PLANNING & ZONING COMMISSION JANUARY 3, 2023

LEE RESIDENCE
507 97 CIRCLE BLUE RIVER, COLORADO

TO: Michelle Eddy, CMC/CPM - Town Manager/Clerk
FROM: Kyle Parag, Plan Reviewer/Building Official - CAA
DATE: December 19, 2022
RE: Planning/Zoning/Architectural Guidelines review – 0507 97 CIR

SP1.0

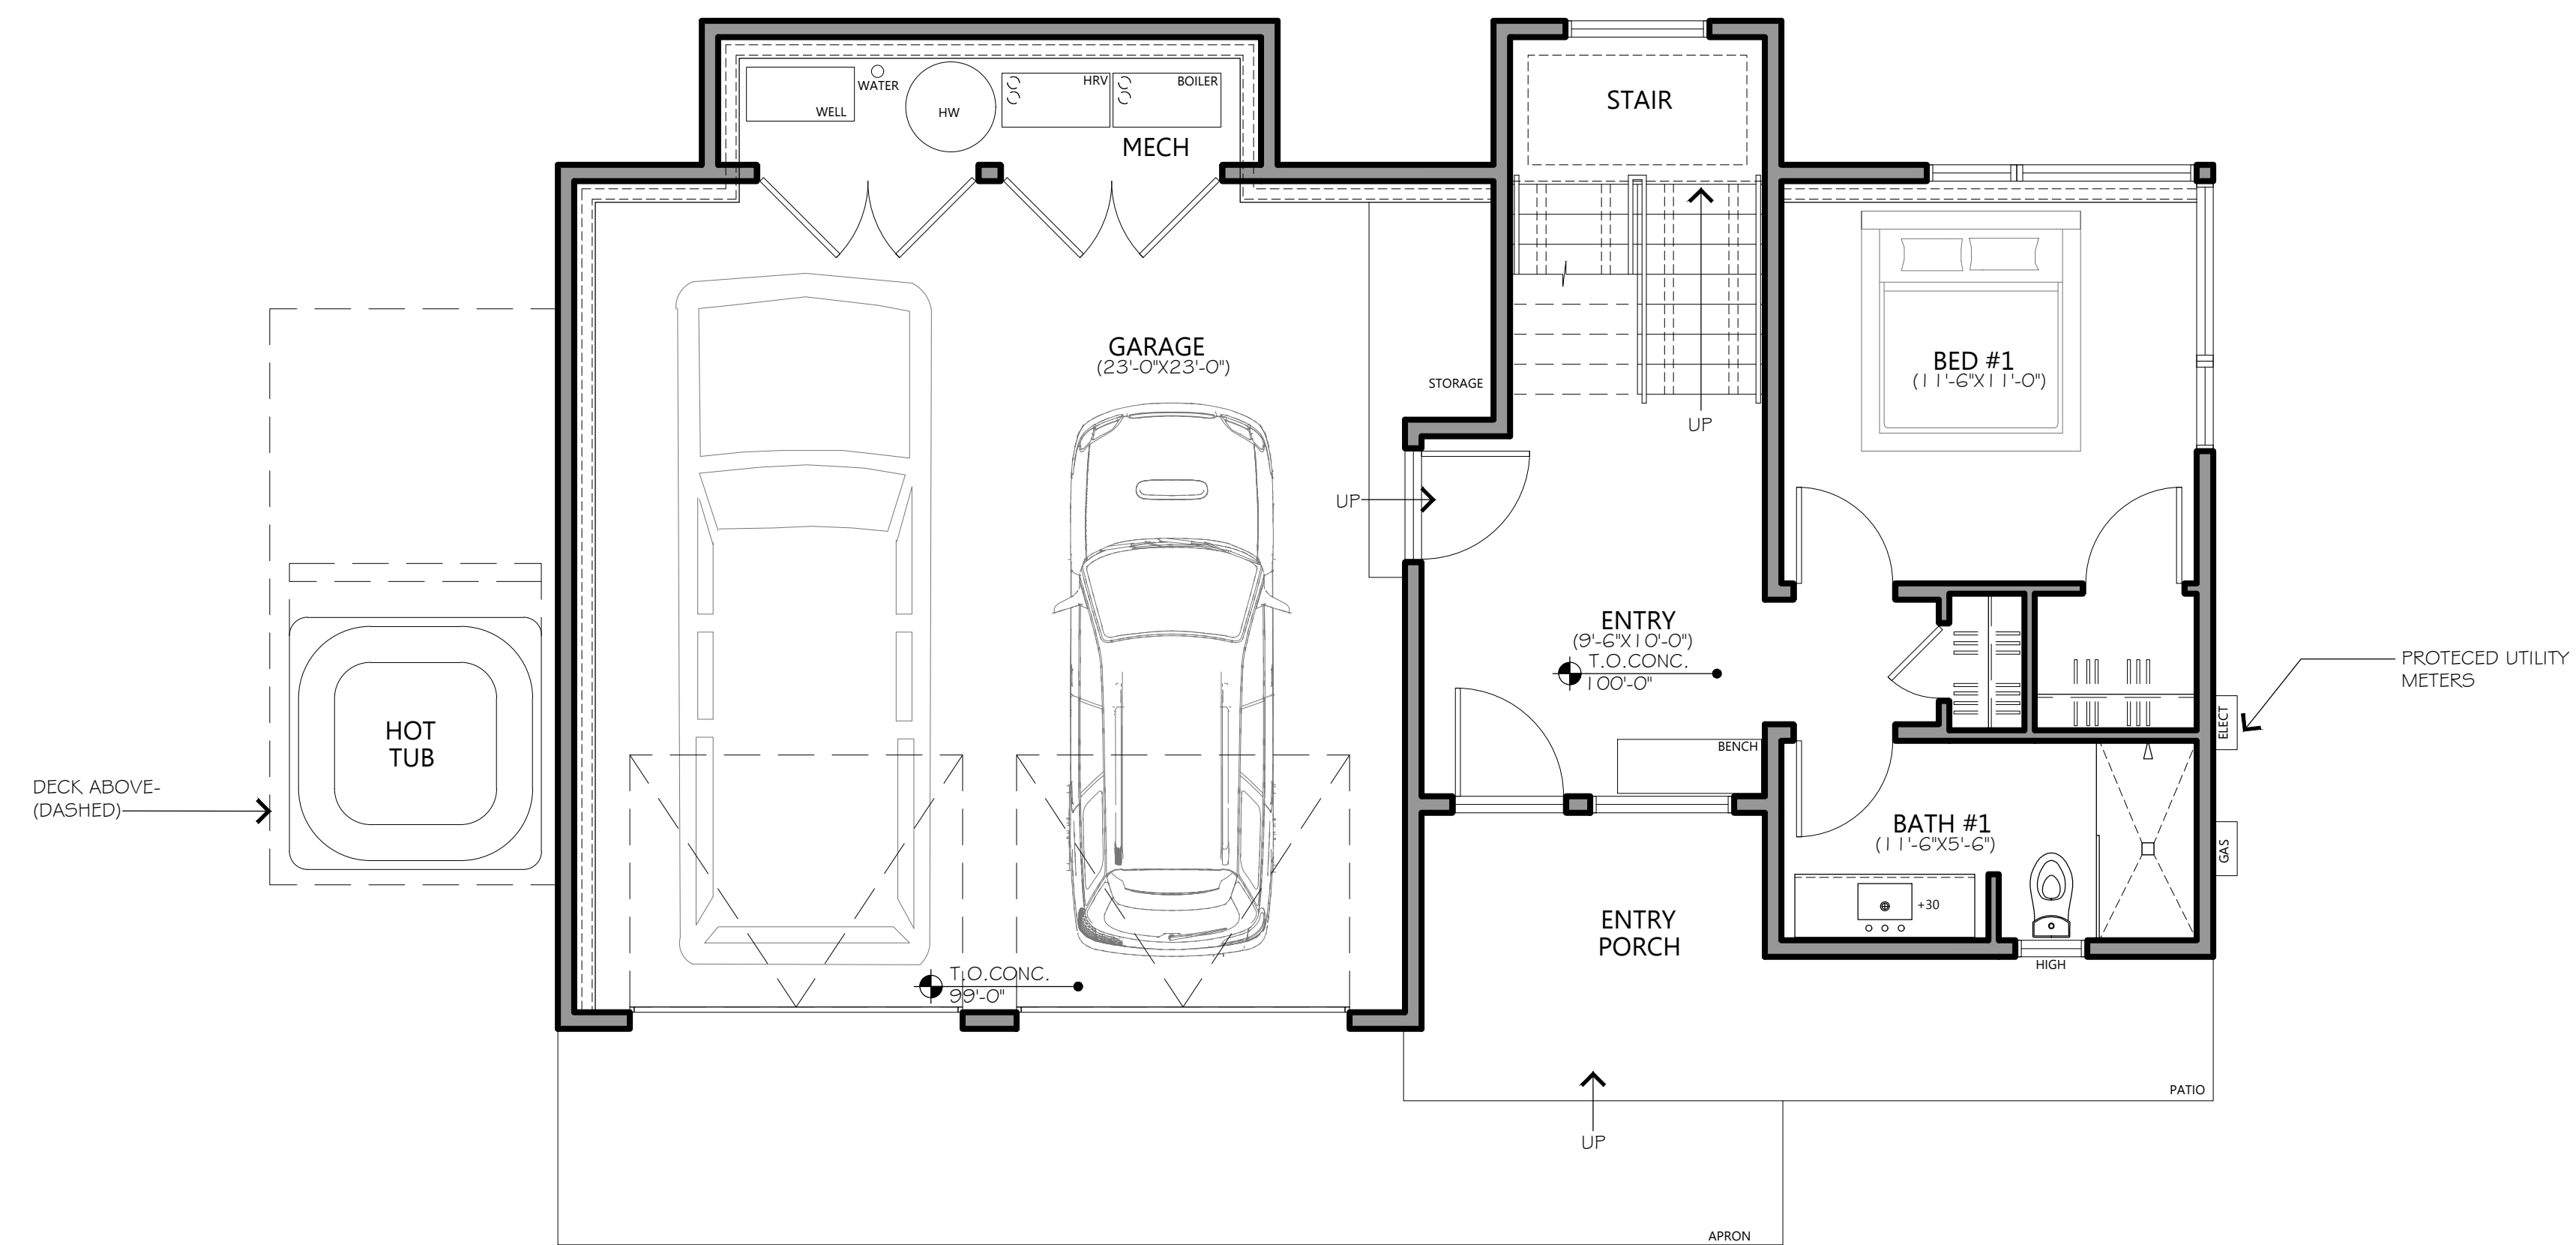
STANDARD	NOTES/REMARKS	SUBSTANTIAL COMPLIANCE
DEVELOPMENT STANDARD		
VI. B. Building Envelope	The submitted site plan depicts compliance, significant work is proposed to be completed in the front yard setback. Landscaping (screening) is depicted in side yard setback.	Y
VI. C. Building Siting	Structure is proposed in context with natural drainage patterns, contours, and landforms.	Y
VI. D. Grading and Drainage	Cut and fill slopes have been kept to a minimum and final grading is proposed to avoid unnaturally broad, flat surfaces.	Y
VI. E. Driveways	Proposed gravel driveway. Snow storage area calculations are provided, but locations are provided beyond the driveway improved area.	N
VI. F. Parking / Garages	The proposed attached 2 vehicle garage complies, However the required third space is provided in the front setback.	N
VI. G. Exterior Equipment and Satellite Dishes	No exterior equipment was identified	Y

VI. H. Easements and Utilities	R.O.W. easements are identified on the plans. Well location is located in front setback. Other easements are not identified.	Y
VI. I. Recreation Facilities	A Hot Tub is proposed under the deck.	Y
VI. J. Signage	No signage is indicated.	Y
VI. K. Pathways /Walkways	The proposed landings, pathways, and walkways comply.	Y
VI. L. Wetlands	Wetlands are identified on the plans. Location to wetlands is immediate, and disturbance of the wetlands impracticable to avoid. Applicant will need to demonstrate proper permits or creative construction methods before proceeding.	N
VI. M. Wildfire Regulations	Many of the required regulations are operational requirements post-construction.	Y
ARCHITECTURAL GUIDELINES		
VII. B. Building Forms	Proposed foundation walls merge with the existing grade, vertical walls appear to be illustrated with appropriate materials. Remaining building elements are wood or wood like appearance. Roof will shed on to lower low slope roof.	Y
